AN ORDINANCE AUTHORIZING A CHANGE ORDER TO THE CONTRACT WITH LAKE ERIE ELECTRIC, INC., OF WESTLAKE, OHIO FOR ADDITIONAL ELECTRICAL WORK FOR THE OBERLIN WATER ENVIRONMENT PROTECTION FACILITY PROJECT FOR THE PUBLIC WORKS DEPARTMENT AND DECLARING AN EMERGENCY

Subject: Oberlin WEPF Improvements Project - Change Order 6 - Items 6.1 and 6.2
for Contract 96-2 *Lake Erie Electric, Inc.*

Reference: Water Environment Protection Facility
City of Oberlin
Electrical Revisions at Grit Building
Our Estimate No. 110-126-E41-R1

3 FLOOR PLAN
1/4"=1'-0"

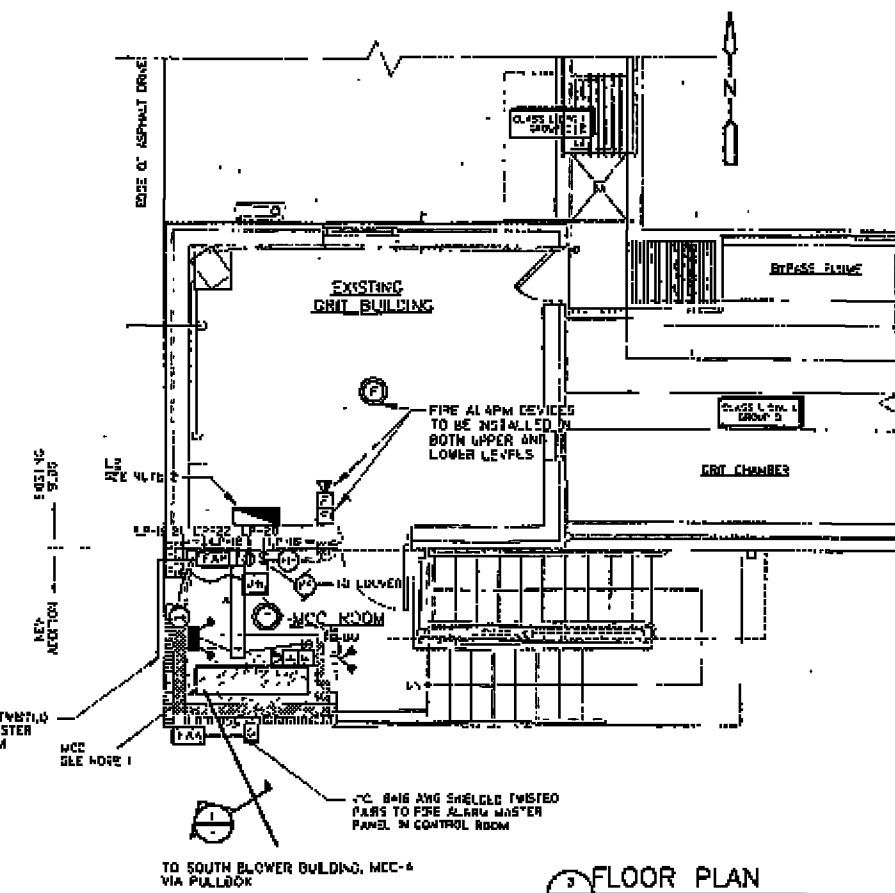
- ③ ALL CABLE WIRE AND CONDUIT FOR CONDUITS FURNISHED AND INSTALLED BY MECHANICAL CONTRACTOR.
- NOTES:
1. MOVE EXISTING MCC FROM ITS PRESENT LOCATION IN EXISTING BAY BUILDING, EXCEPT EXISTING CONDUITS AND WIRE TO NEW MCC LOCATION.

2. DISCONNECT EXISTING WIRING FROM EXISTING EXHAUST PANEL "1-P", REPLACE EXISTING PANEL "1-P" WITH NEW 120/240 VOL. 1 PHASE 3 WIRE 100 AMP PANELBOARD IN PANEL-4 ENCLOSURE WITH BRANCHED CIRCUIT BREAKERS AS SHOWN ON PANEL SCHEDULE. RECONNECT EXISTING WIRE TO NEW PANELBOARD.

3. CONDUIT AND WIRE FOR FURNACES FANS THERMISTATE, SWITCHES AND/OR NEW FANER SHALL BE FURNISHED AND INSTALLED BY THE MECHANICAL CONTRACTOR AND SHALL BE:

FIRE ALARM RISER DIAGRAM

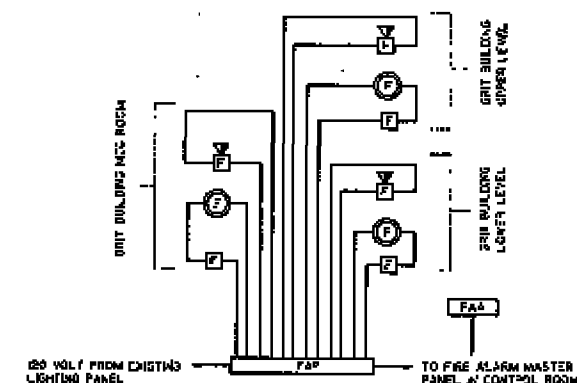
6.1 - Electrical Work in Grit Building Addition - The cost for relocating the Grit Building Motor Control Center (MCC) to the new building addition was part of Change Order 5 (Item 5.2). The scope of work for this item includes providing the new fire alarm system and providing power to the unit heater, ventilating fan, motorized louver, thermostats, lighting, and the fire alarm system. The scope of work does not include the furnishing and installation of a new lighting panel; this will be a part of a separate change order. The cost for this item is \$16,623.35.
